Table 87–8—40GBASE–LR4 receive characteristics

87.8.11 Stressed receiver sensitivity

Figure 87-3—Stressed receiver conformance test block diagram

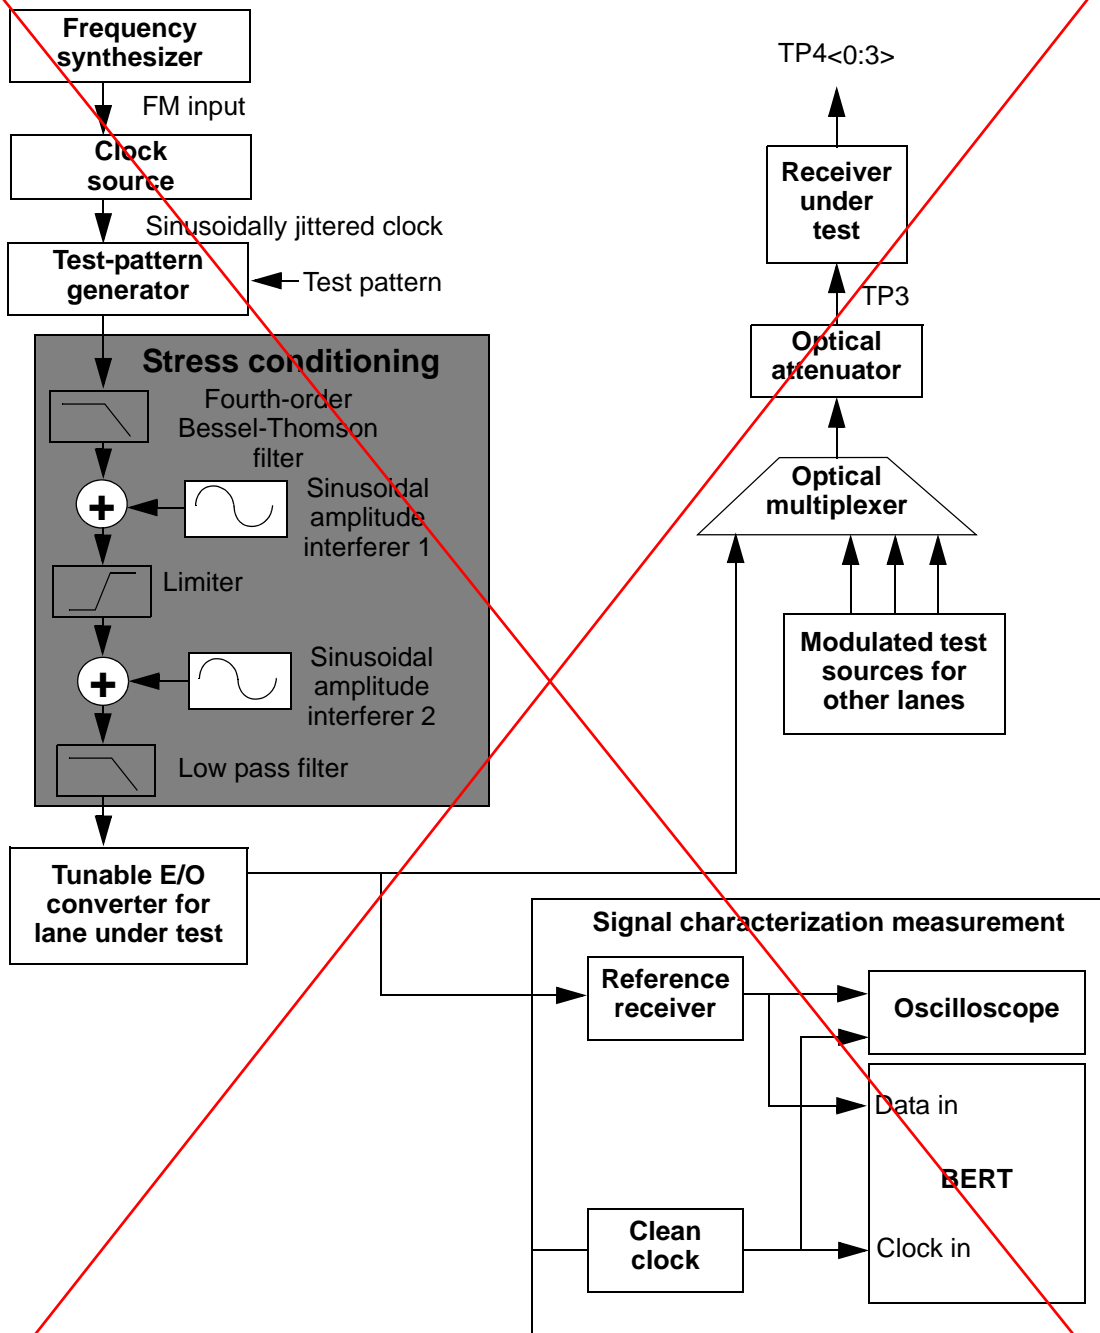
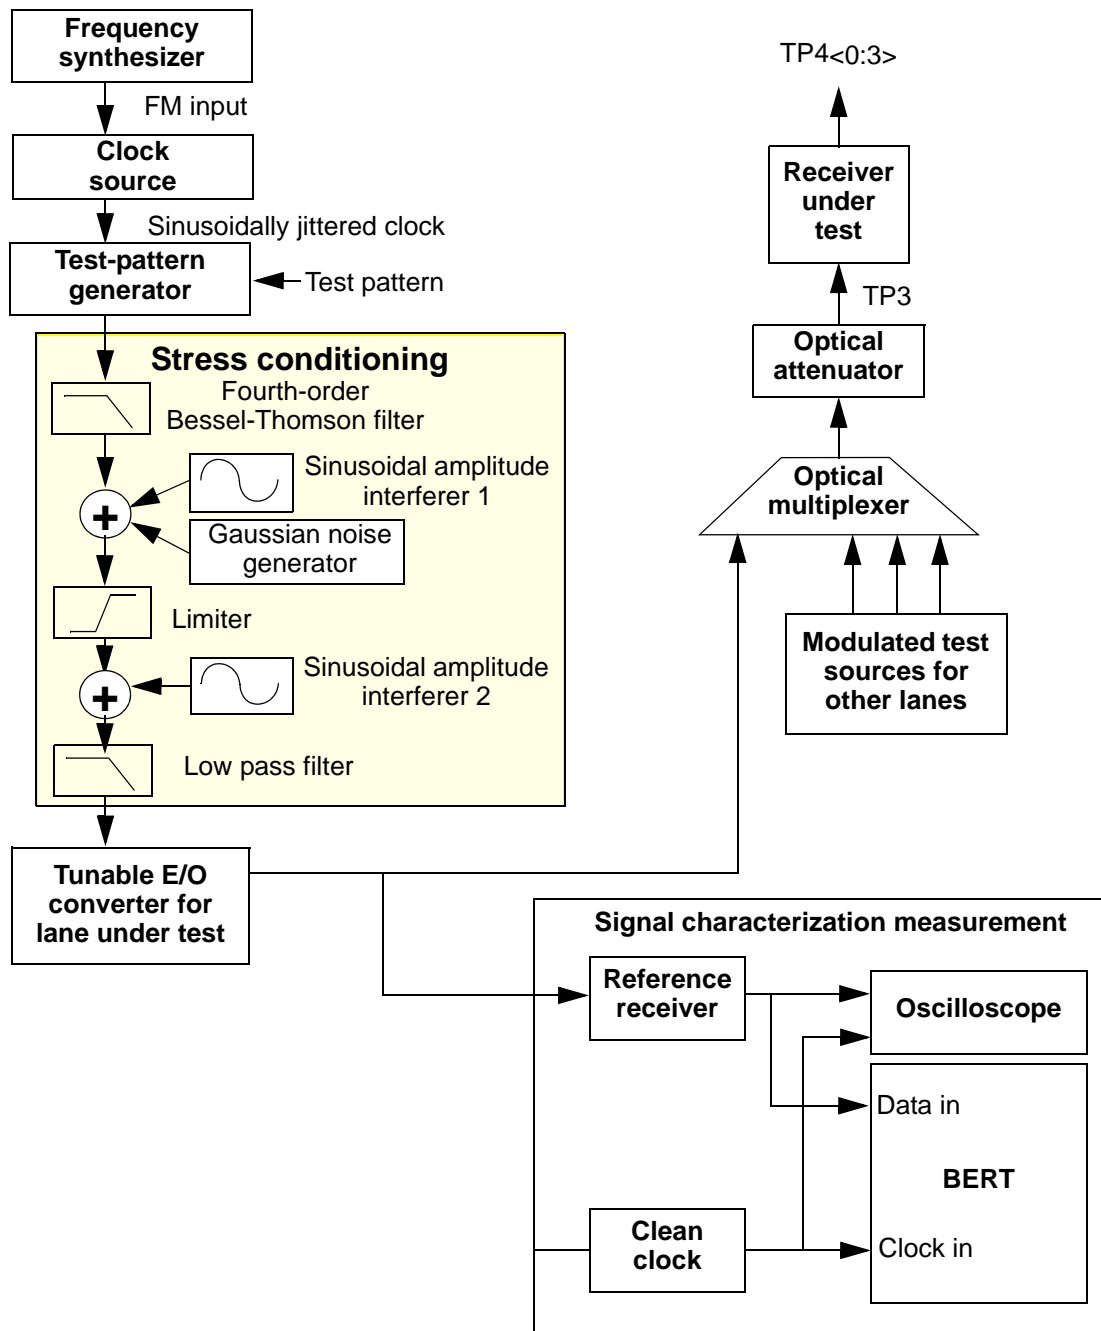
The low pass filter is used to create ISI-induced vertical eye closure penalty (VECP). The low pass filter, when combined with the E/O converter, should have a frequency response which results in the appropriate level of initial vertical eye closure before the sinusoidal terms are added.

The sinusoidal amplitude interferer 1 causes jitter which is intended to emulate instantaneous bit shrinkage that can occur with DDJ. This type of jitter cannot be created by simple phase modulation. The sinusoidal amplitude interferer 2 causes additional eye closure, but in conjunction with the finite edge rates from the limiter, also causes some jitter. The ~~sinusoidally~~ sinusoidally jittered clock represents other forms of jitter and also verifies that the receiver under test can track low-frequency jitter. The sinusoidal amplitude interferers may be set at any frequency between 100 MHz and 2 GHz, although care should be taken to avoid harmonic relationships between the sinusoidal interferers, the sinusoidal jitter, the signaling rate and the pattern repetition rate. The Gaussian noise generator, the amplitude of the sinusoidal jitter and the Bessel-Thomson filter are adjusted so that the VECP, J2 Jitter and J9 Jitter specifications given in Table 87–8 are simultaneously met.

For improved visibility for calibration, all elements in the signal path (cables, DC blocks, E/O converter, etc.) should have wide and smooth frequency response, and linear phase response, throughout the spectrum of interest. Baseline wander and overshoot and undershoot should be minimized. ~~Random noise effects, such as RIN and random clock jitter, should also be minimized. Some residual noise and jitter from all sources is unavoidable, but more than 0.25 UI peak-to-peak jitter at the 10⁻¹² points is not acceptable. If this is achieved, then pattern dependent effects should be minimal, and short patterns can be used for calibration with the benefit of providing better trace visibility on sampling oscilloscopes.~~
